Product Change Notification / ALAN-20BLUP482

CCB 4847 Final Notice: Qualification of ATP7 as an additional assembly site for selected Atmel ATSAM51Jxx and ATSAME5xx device families available in 64L VQFN (9x9x1.0mm) package.

**PCN #: ALAN-20BLUP482**

**CCB 4847**  
**Pre and Post Change Summary**  
**PCN# ALAN-20BLUP482**

## ASE Inc. (ASE)

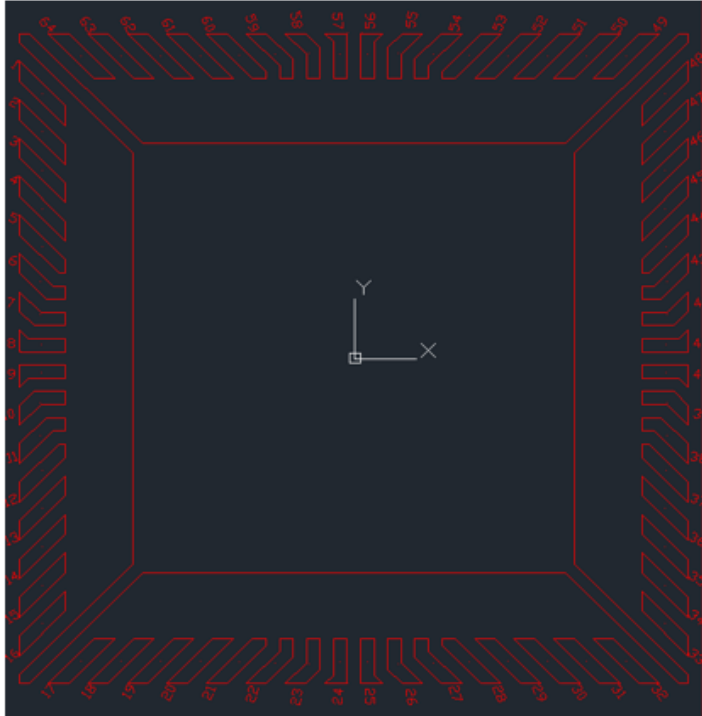
Material	C194
Paddle size	193 X 193 mils

## Amkor Technology Philippines (P3/P4), INC. (ATP7)

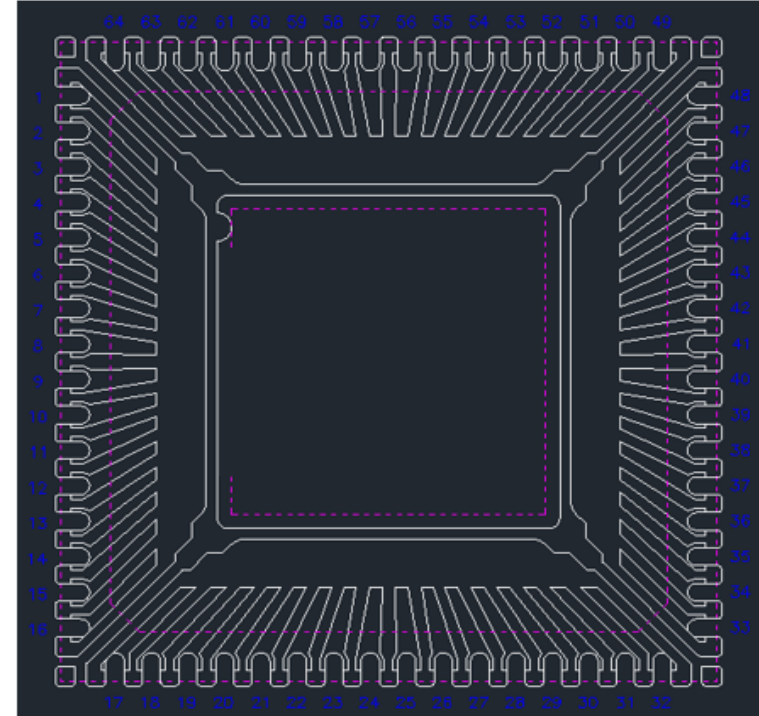
Material	C194
Paddle size	197X197 mils
